THM 4T40-E TRANSAXLE CASE, CHANNEL PLATE AND CHECKBALL LOCATION CHANGES FOR 1997

CHANGE: Beginning in the middle of the 1997 model year, the transaxle case, channel plate and the checkball locations were changed on all THM 4T40-E transaxles, that may create some confusion for service.

Figure 2

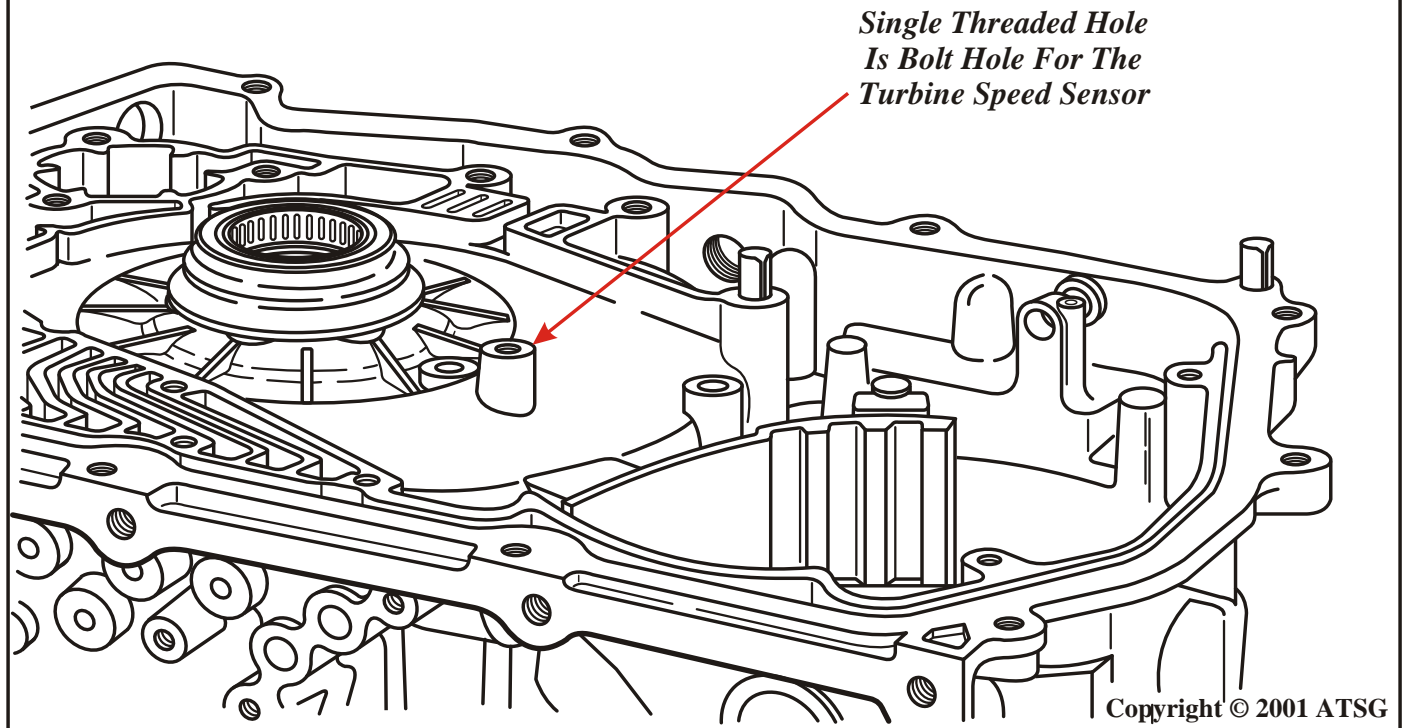
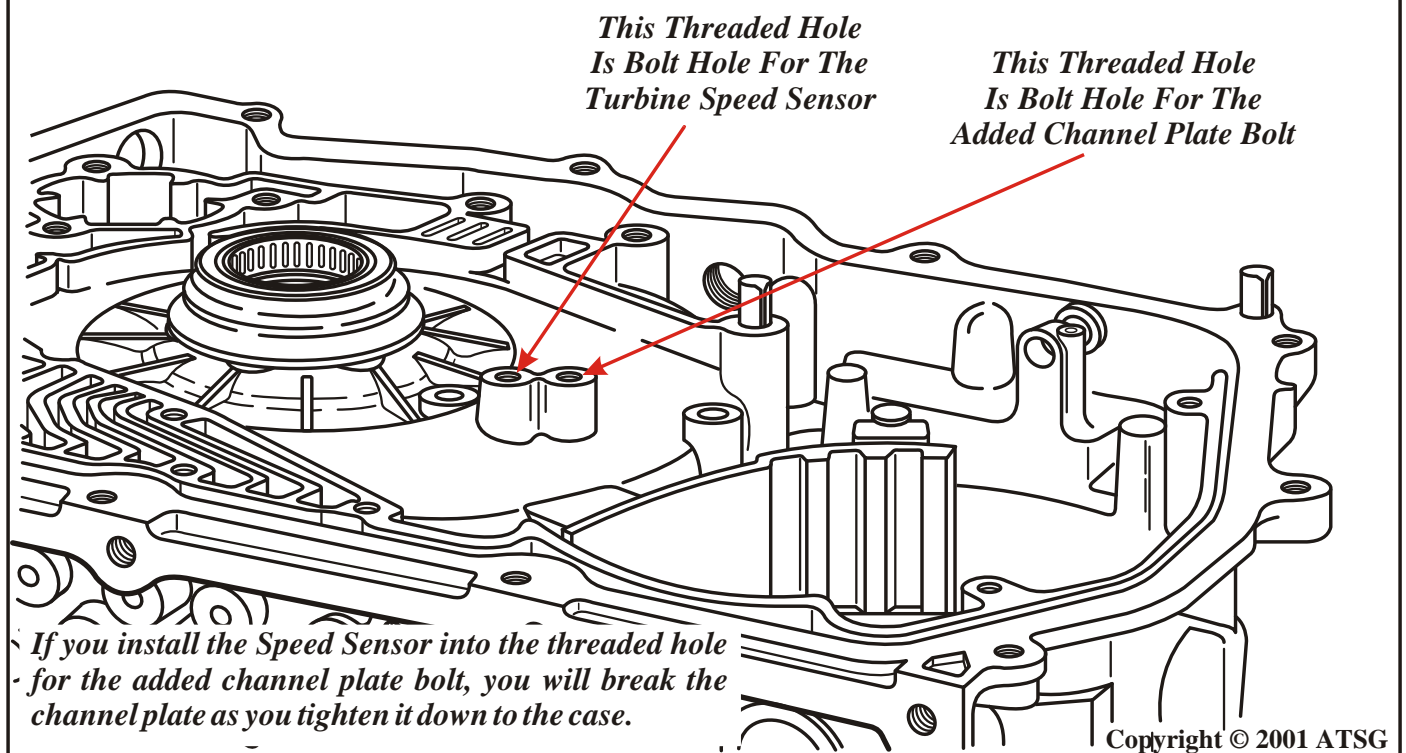
- (1) **TRANSAXLE CASE** - Added boss and the second threaded hole to the case in the area shown in Figure 2, to accommodate valve body bolt and channel plate changes for improved clamping. The previous design case, with the single boss and hole is shown in Figure 1.

When using the 1997 and later case with the two threaded holes in the case, as shown in Figure 2, the Turbine Speed Sensor must be installed in the hole closest to the turbine shaft hole, as shown in Figure 2.

If you install it into the threaded hole for the added channel plate bolt, you will break the channel plate as you tighten it down to the case. Some people will break two!

Figure 4

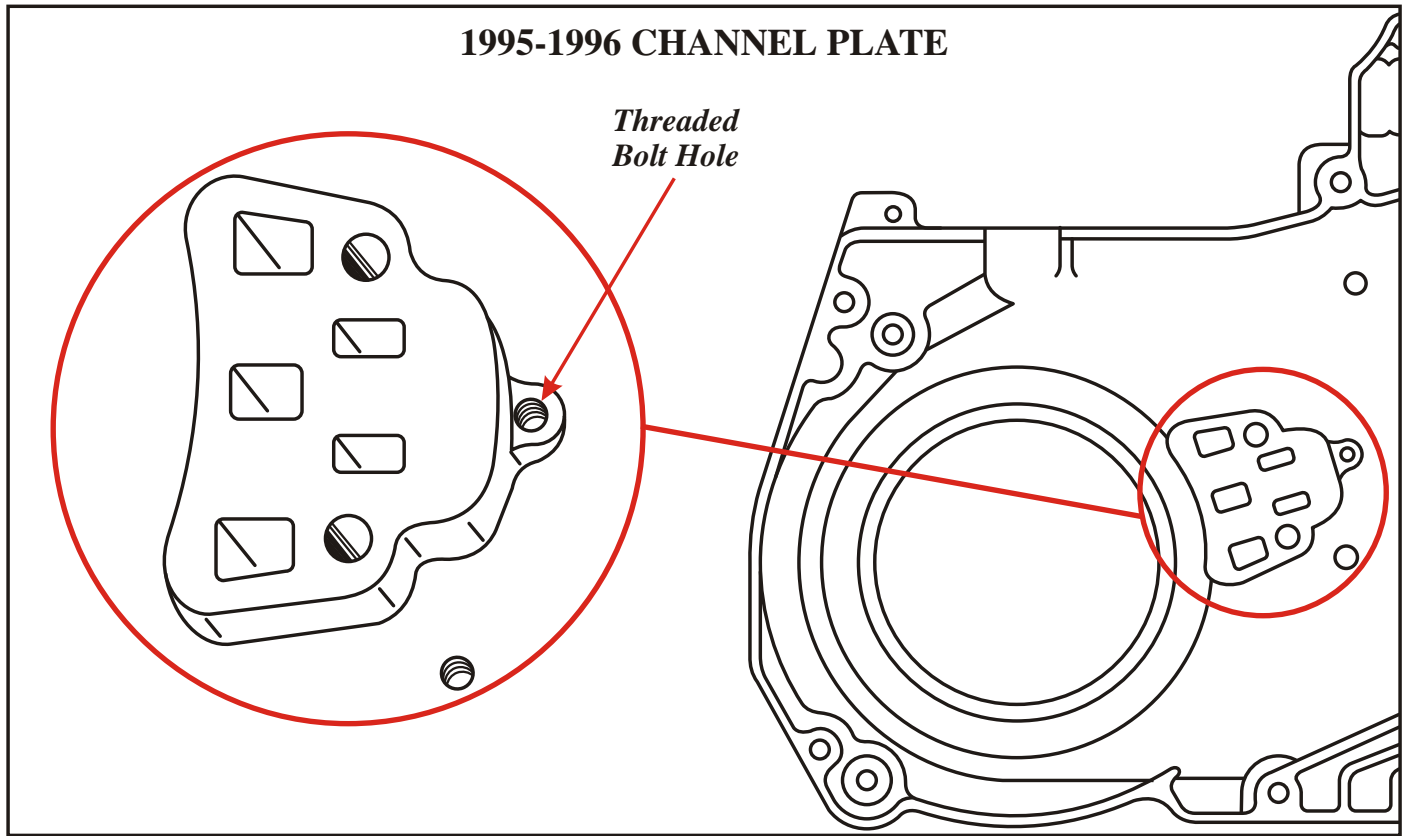
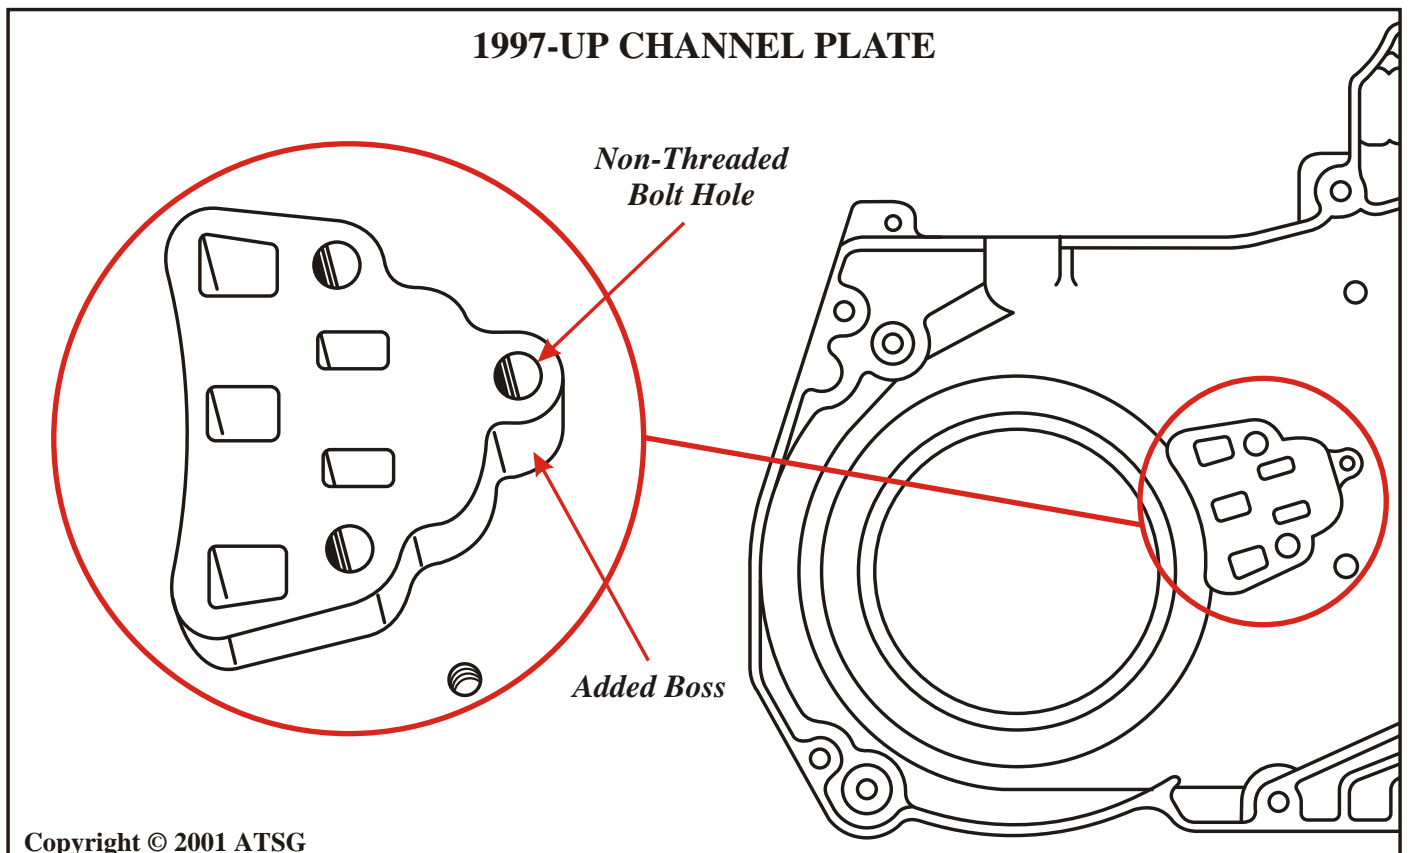
- (2) **CHANNEL PLATE** - New casting with an added boss, and one of the threaded holes in the channel plate changes to a non-threaded hole to accommodate the valve body bolt changes for improved clamping force. The previous design channel plate is shown in Figure 3, and the new design channel plate is shown in Figure 4.

Figure 6

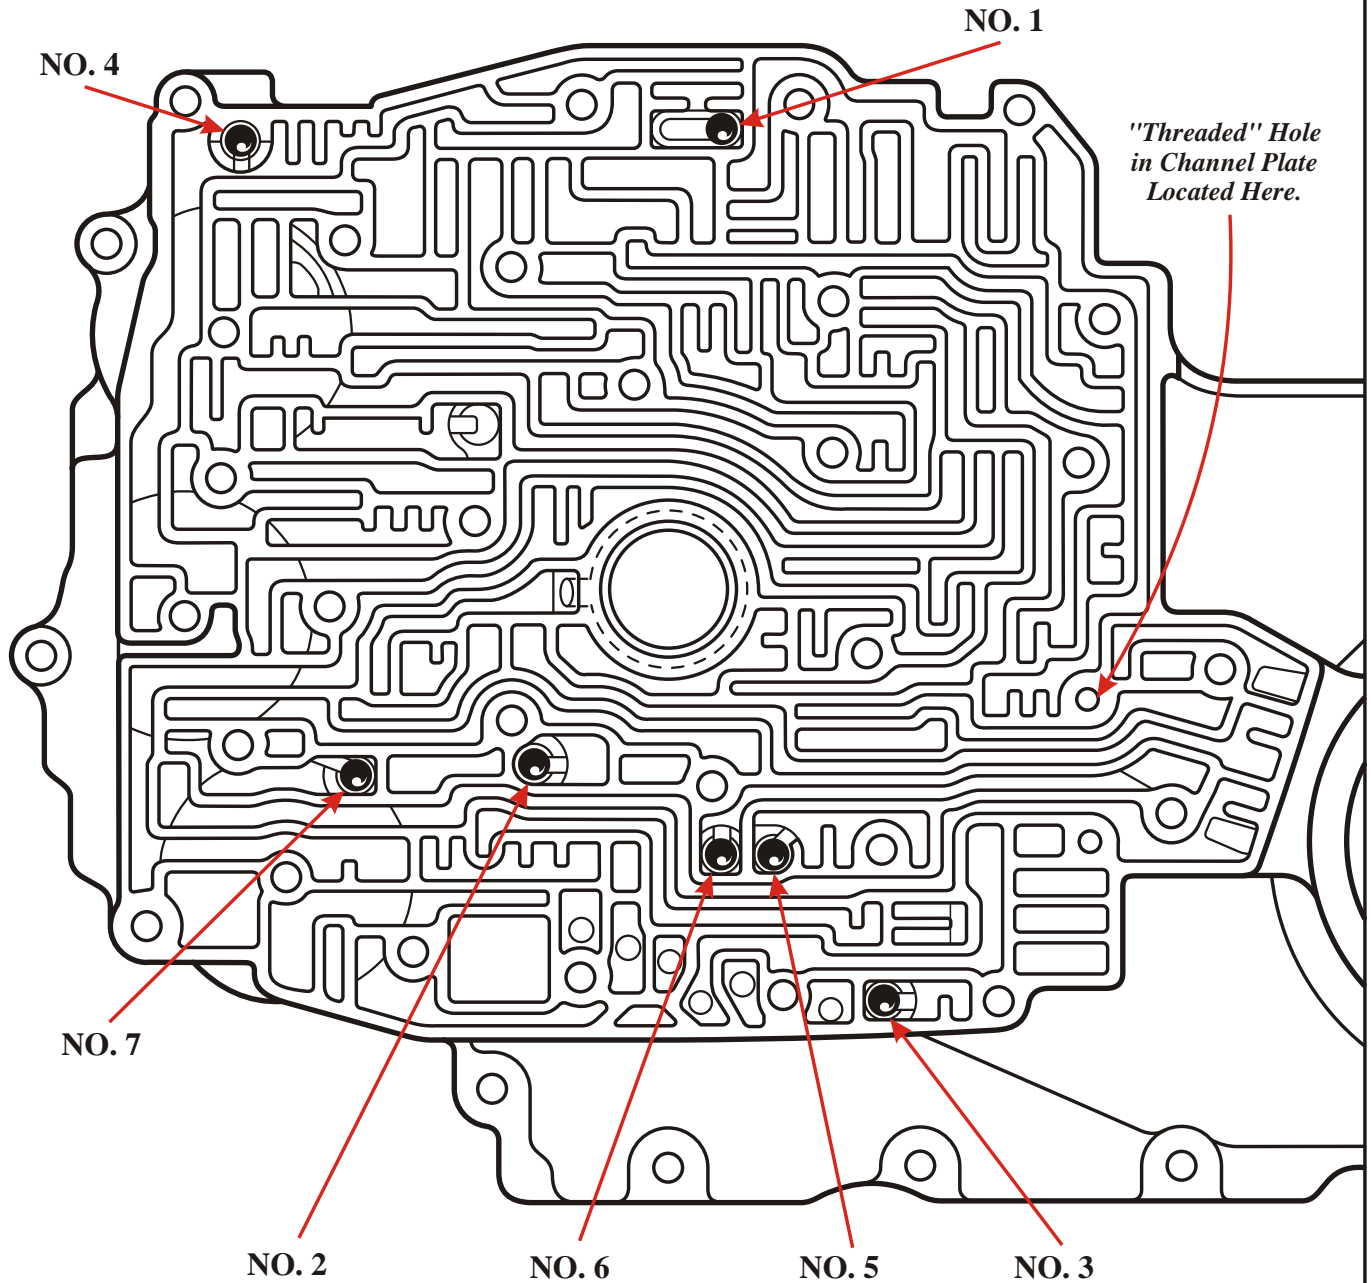
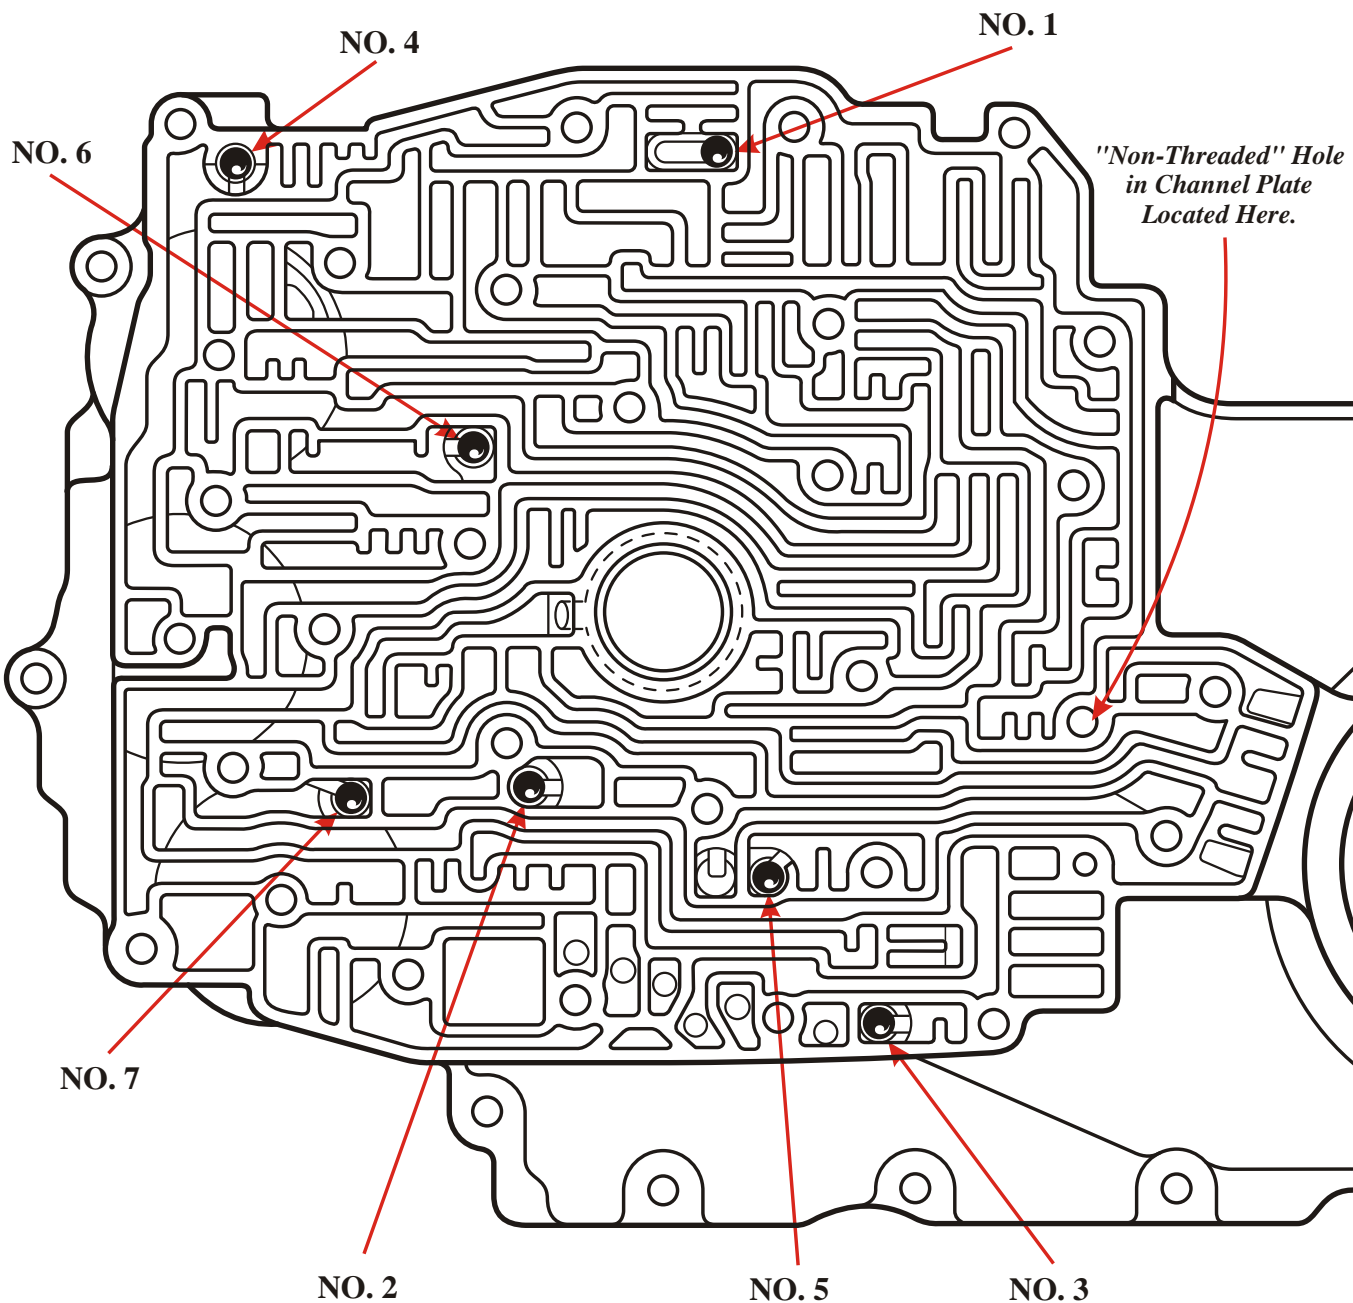
- (3) **CHECKBALL LOCATIONS** - The number 6 checkball moves from the direct clutch apply circuit, and into the 2-3 accumulator circuit. There were no changes in worm track configuration, however we also show the "Threaded" hole that changed to a "Non-Threaded" hole in the channel plate. Refer to Figure 5 for 1995-1996 checkball locations, and Figure 6 for the 1997-Up checkball locations.

Figure 8
AUTOMATIC TRANSMISSION SERVICE GROUP

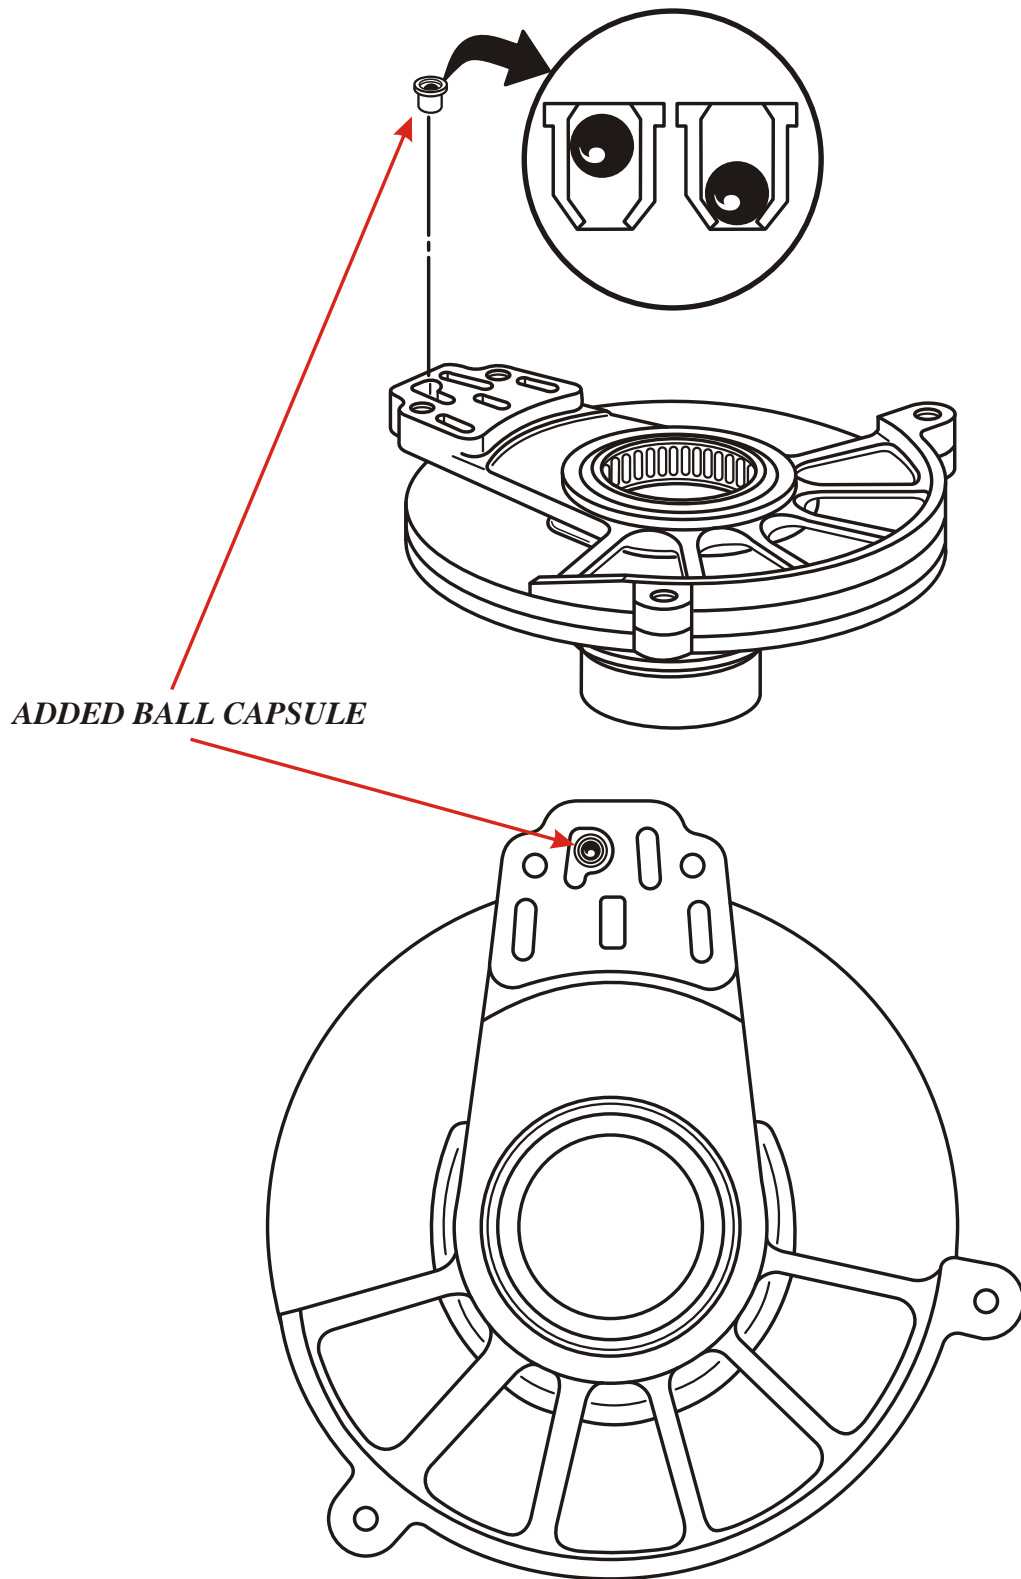
- (5) **DRIVEN SPROCKET SUPPORT** - Ball capsule added in the direct clutch circuit to act as an air bleed to improve direct clutch apply, as shown in Figure 8.
